Architect's Supplemental Instructions

PROJECT: *(name and address)*
Wilma P. Mankiller Health Center
Expansion
Stilwell, OK

ASI INFORMATION:
ASI Number: Bid Package 01 - ASI 002

Bid Package 01- ASI 02 – Wilma P. Mankiller Health Center Expansion

A1 LOW ROOF FRAMING PLAN
SCALE: 1/8" = 1'-0"

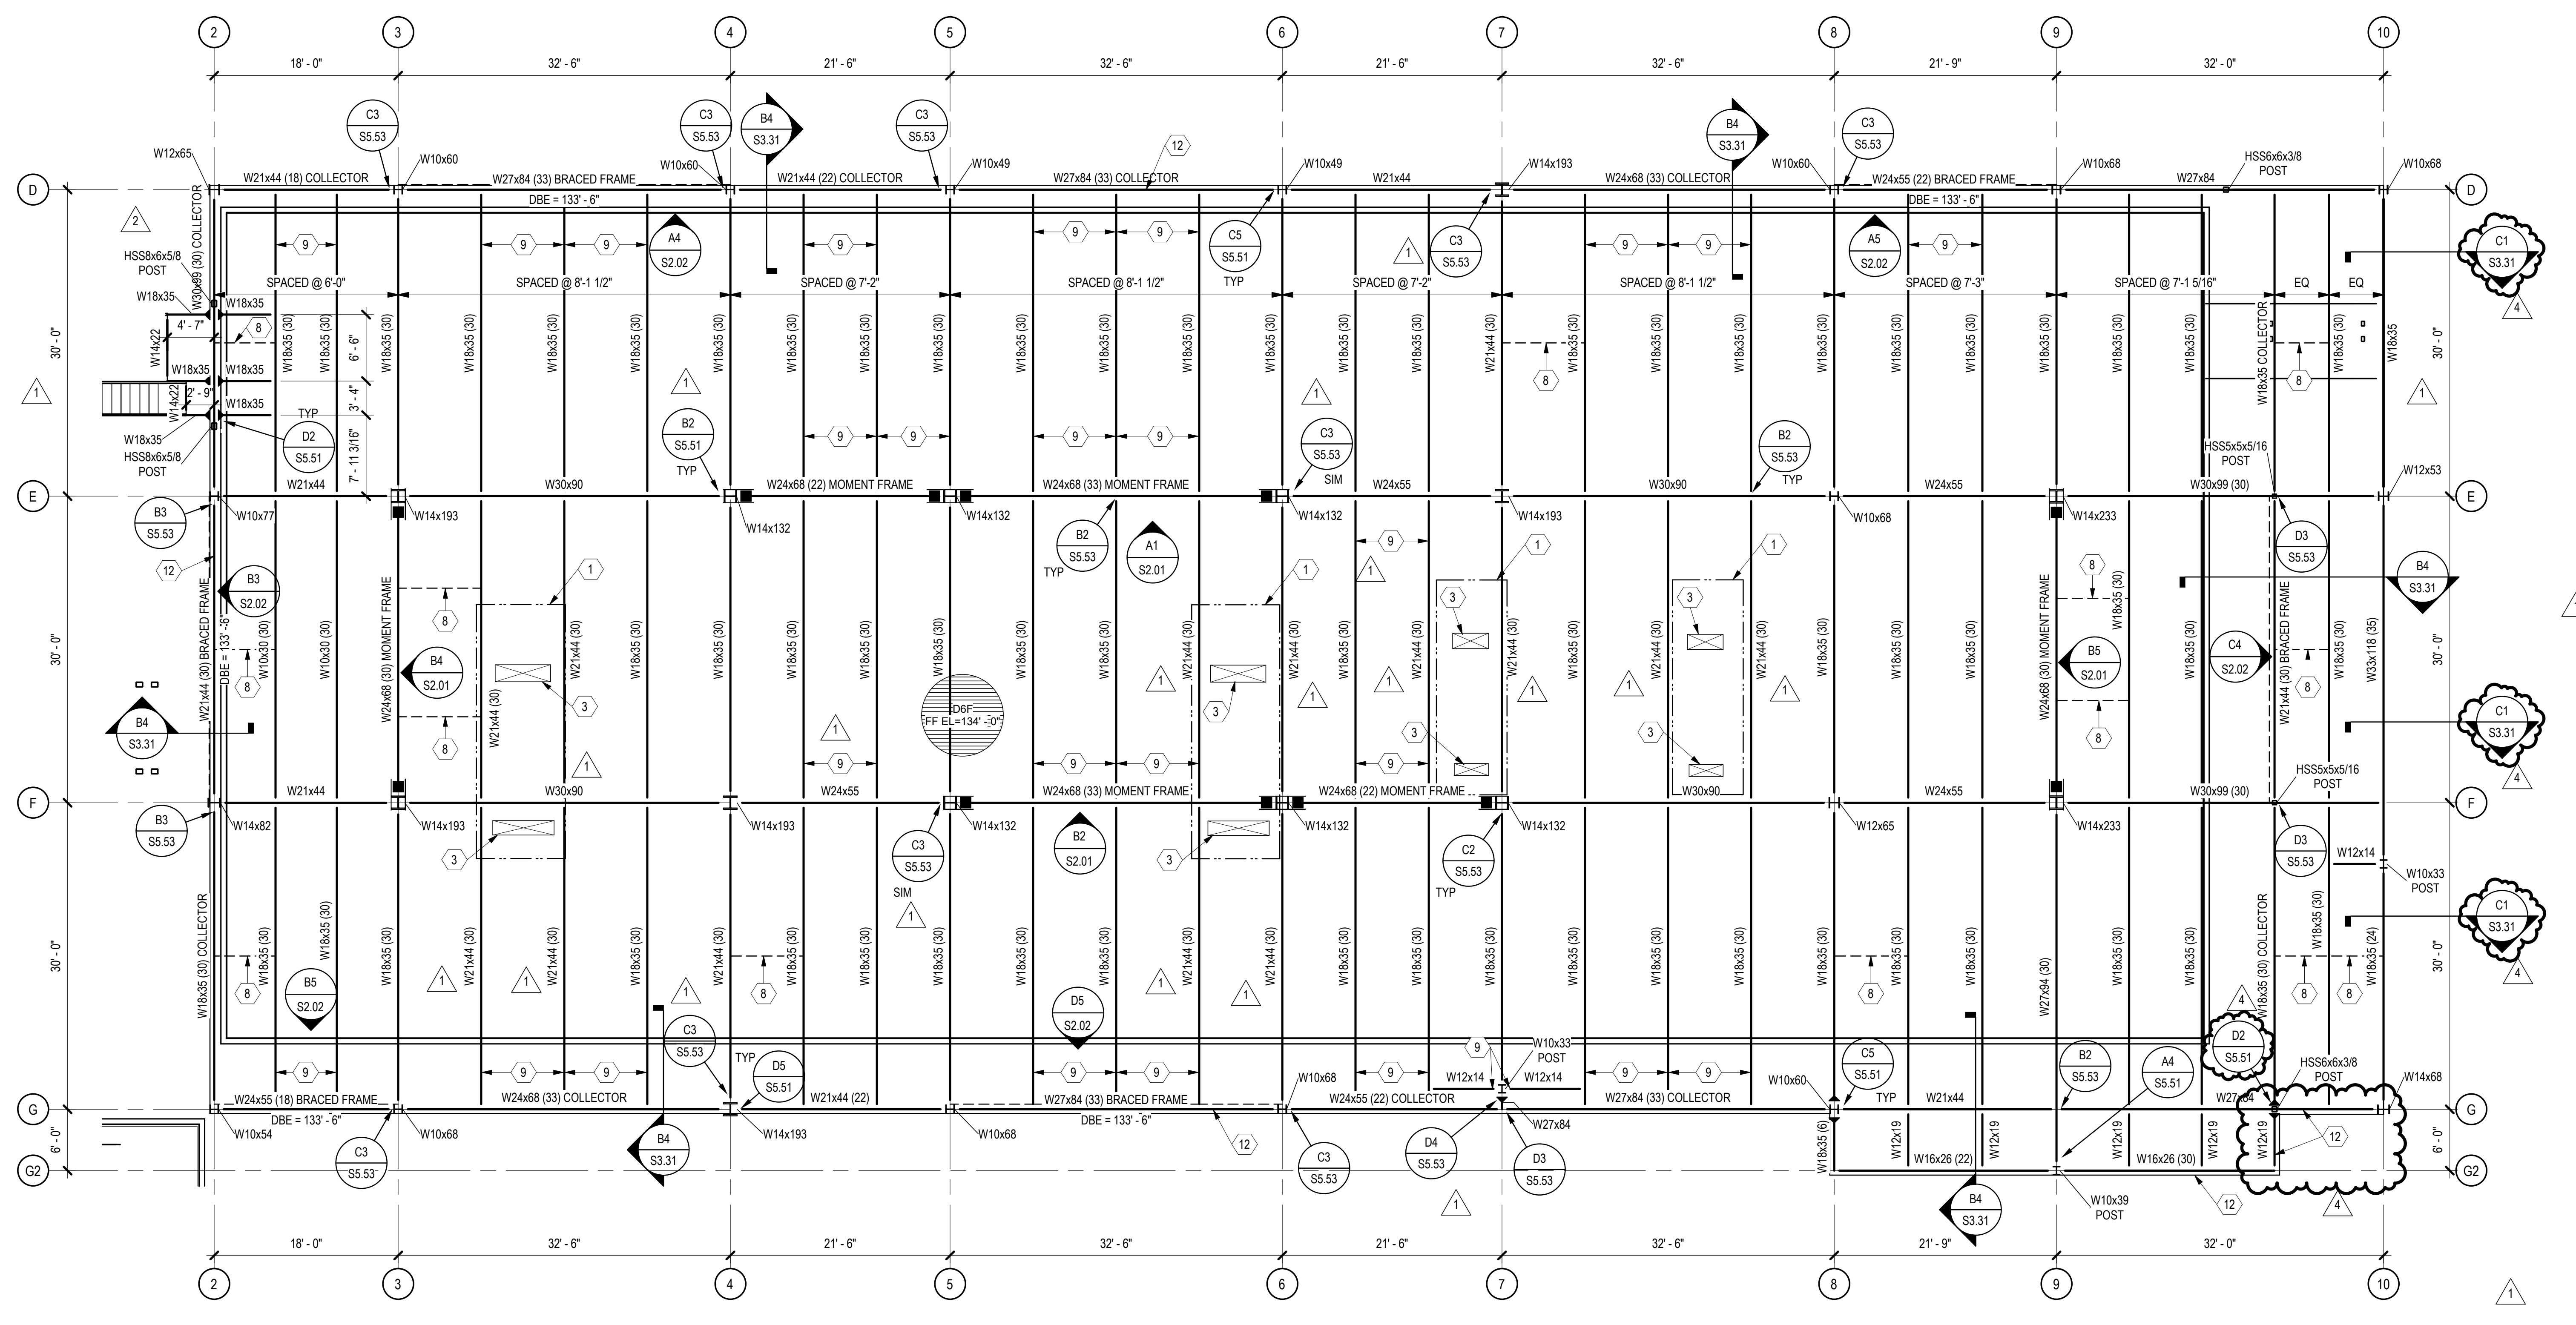
<u>Sheet</u>	<u>Description</u>
S1.13	Sheet keynote 12 removed from Grid 10.
S1.13	Section C1/S3.31 cut along Grid 10.
S1.13	Framing and deck edge near Grid G/10 modified.
S1.21	Beam sizes updated along Grid 10, between Grids G and D.
S1.21	Section C1/S3.31 cut along Grid 10.
S3.31	Section C1 added.
